Main Door Hinge Pin with “C” Clip

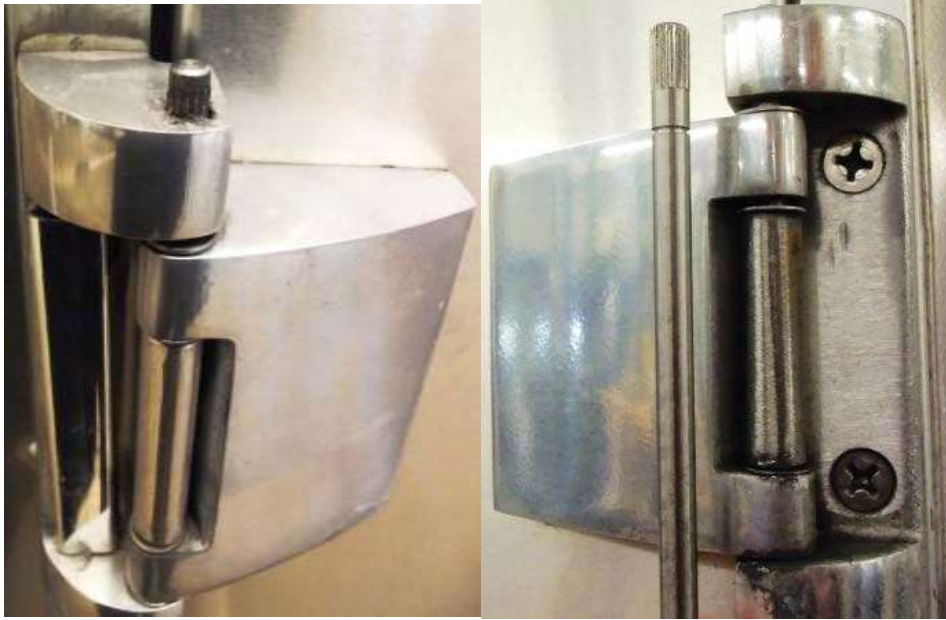
Here is an answer to the question on “how do I keep the main door hinge pin from working out of the castings?” First thought would be to make sure you lubricate the hinge pin at the joints between the inner and outer hinge joints. If the door is not lubricated on a regular basis (once a month, when possible, with something such as graphite or silicone spray) the pin can, over time, begin to collect dirt and or oxidize. The door hinges will then start to bind and can cause the pin to move in the casting versus pivoting on the hinge pin (eventually working its way up). The symptoms will be a door that opens hard or squeaks when opening and the pin can work its way up out of the castings.

Airstream has added a groove to the hinge pin that accepts a “C” clip that is installed at the top hinge joint once the pin has been inserted into the castings.

The part # for the main door hinge pin is 381552-100 & the C clip is 381552-101. This hinge pin will also work on Classic motorhome door hinges as well.
